BZA SUBMITTAL

A New Residence For: Adam & Nikki Sizemore 3605 Rainbow Place, City Of Oak Hill - Zone 'A' Nashville, TN

BZA Meeting : October 17, 2023
Issued : September 29, 2023

Re: BZA Case No 23-54

TREE PRESERVATION PLAN
SIZEMORE RESIDENCE
3605 RAINBOW PLACE
NASHVILLE, TENNESSEE

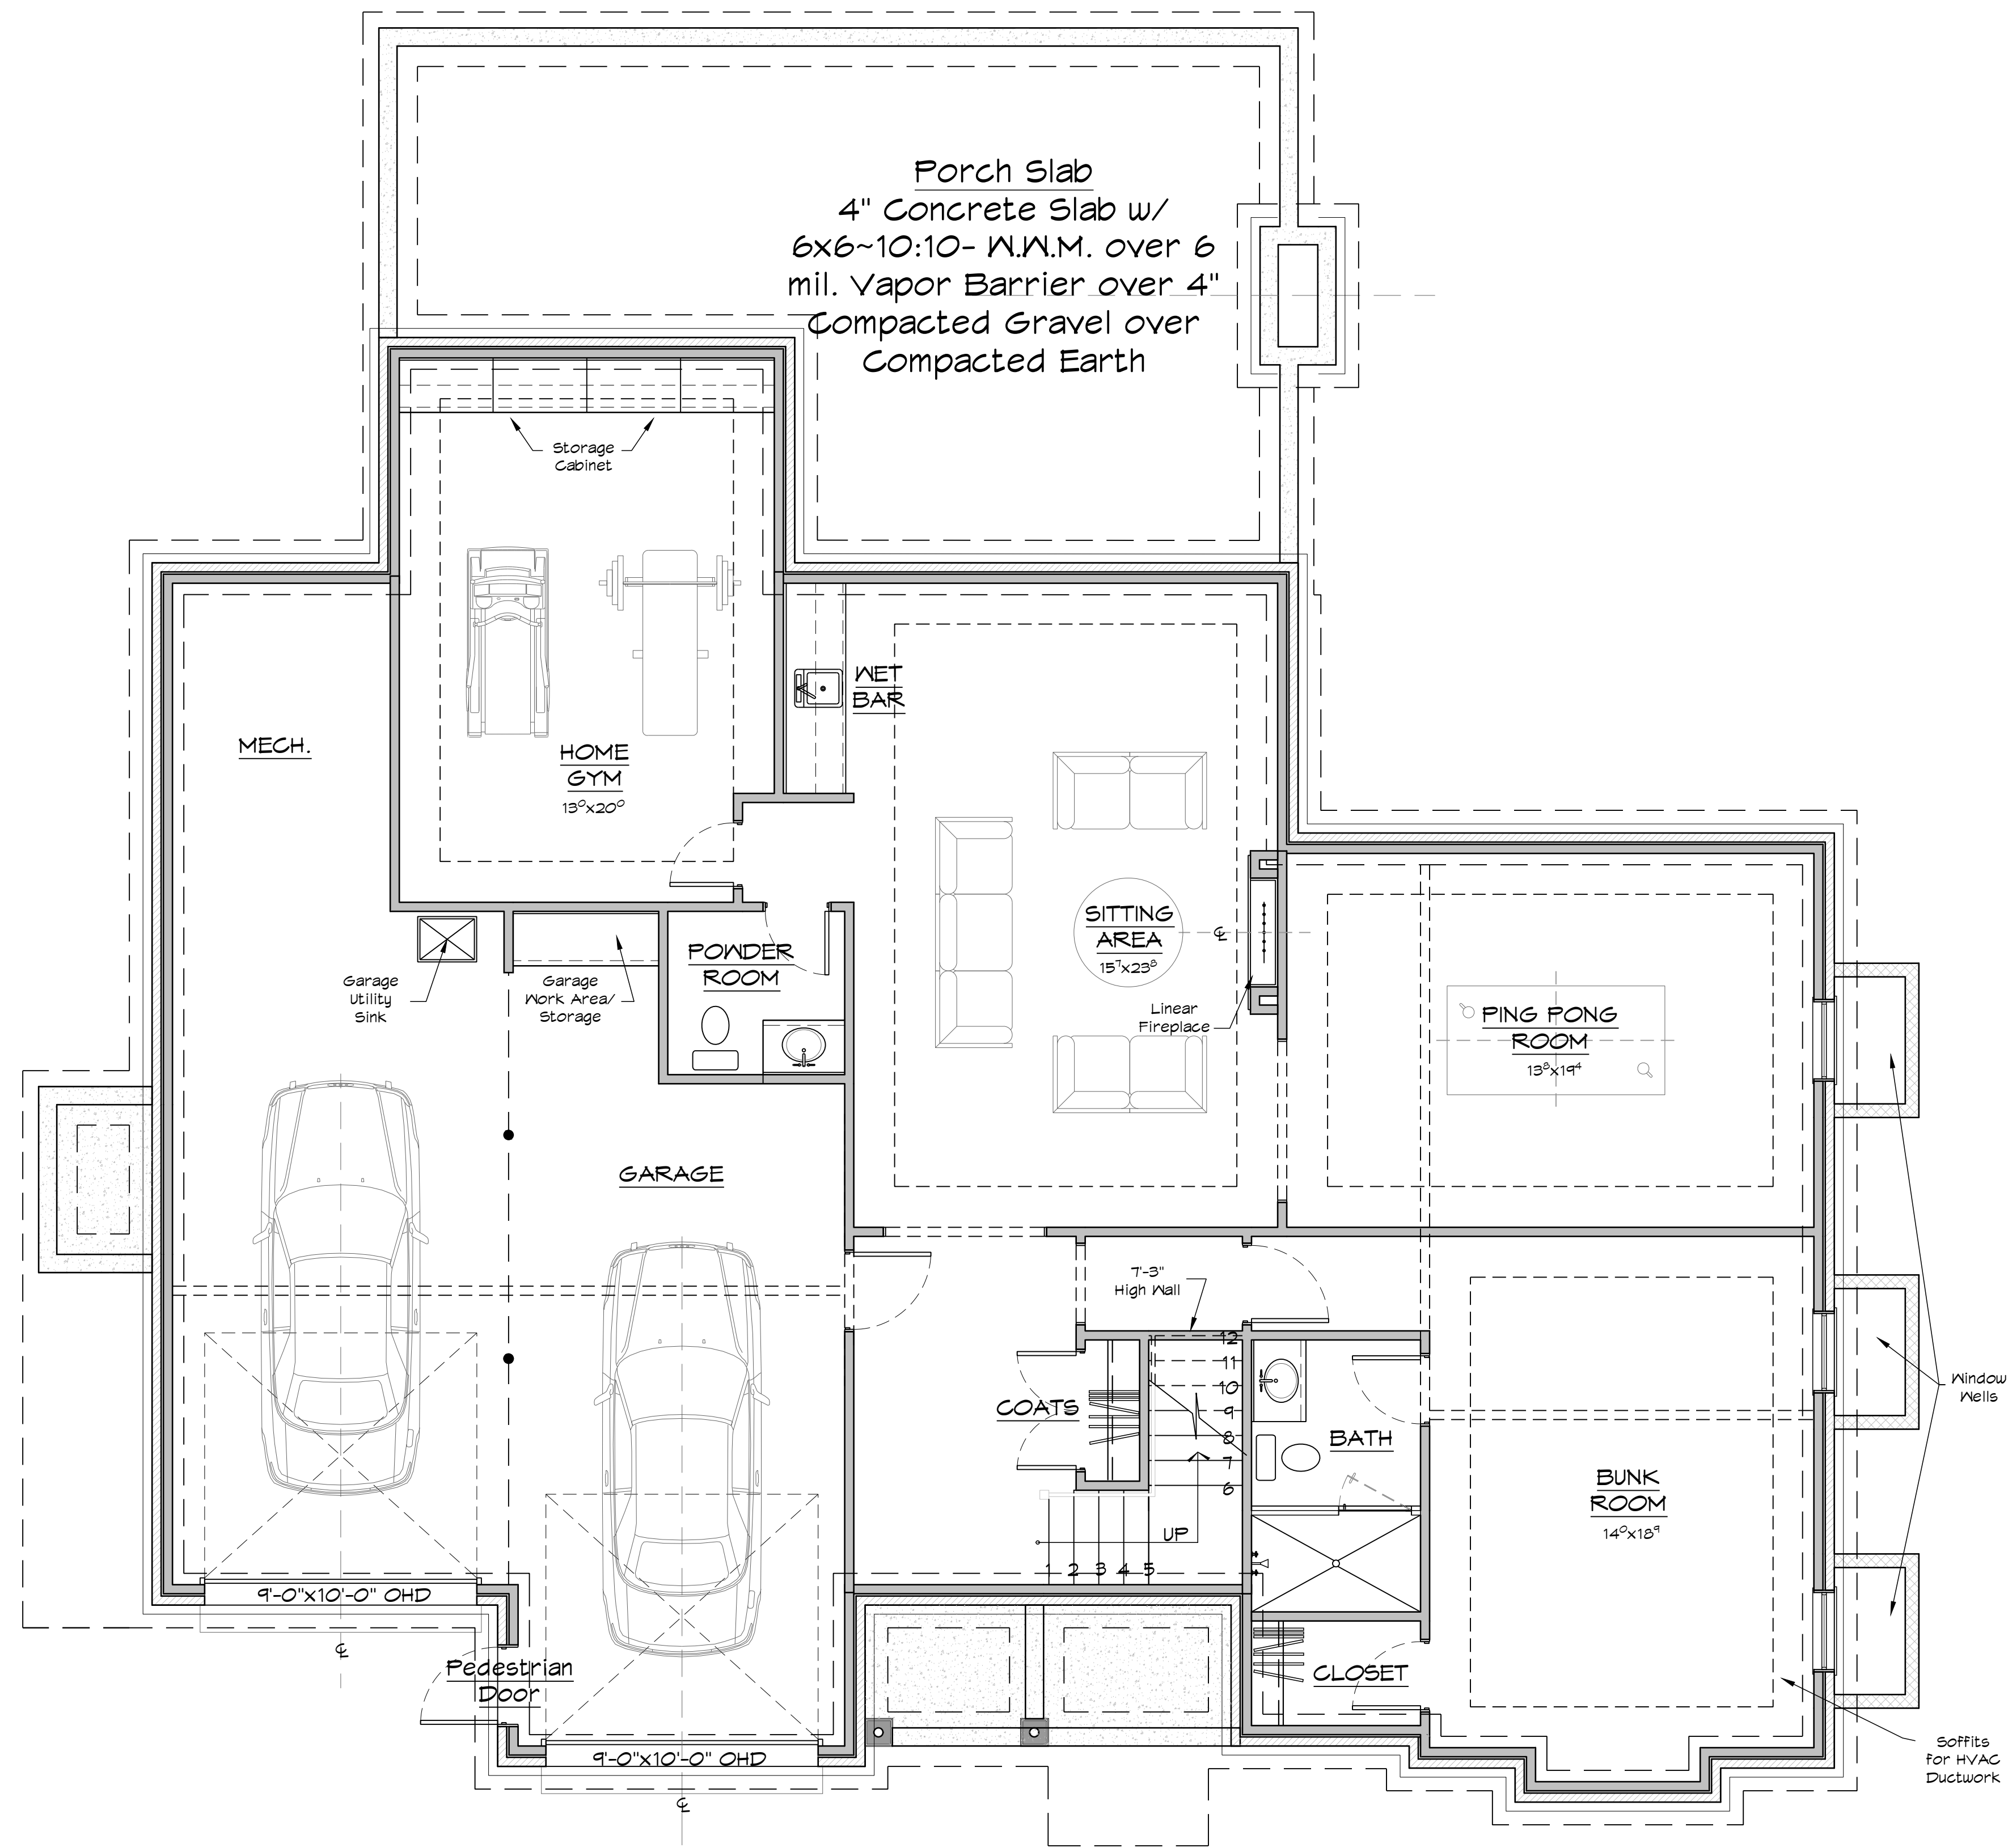
1. The 36" yellow hardwood poplar is almost on the property line of 3603 Rainbow, in the 10 foot setback and is not in the building envelope. I am assuming the developer is requesting this be removed because the root system will be damaged by the retaining wall. Otherwise, I can not understand why this priceless tree canopy should be removed.

2. The 24" pine is right on the edge of what appears to be the retaining wall. If the retaining wall is not necessary this could be saved. The developer says this pine is decayed and unhealthy and will die soon. I would like the Board of Zoning appeals to obtain an independent assessment of this and determine if there is an approach to preserving the tree.

3. The tree replacement strategy in the developer's plan calls for the lost canopy of removed trees to be replaced by Emerald Green Arborvitae. These arborvitae are slender, conical softwood shrubs used for landscaping. They will never come close to replacing the canopy lost to the four trees the developer is proposing to remove. (Please see the attached inquiry of CHAT GPT 3.5.) As such the developer's plan does not include an effective tree replacement strategy.
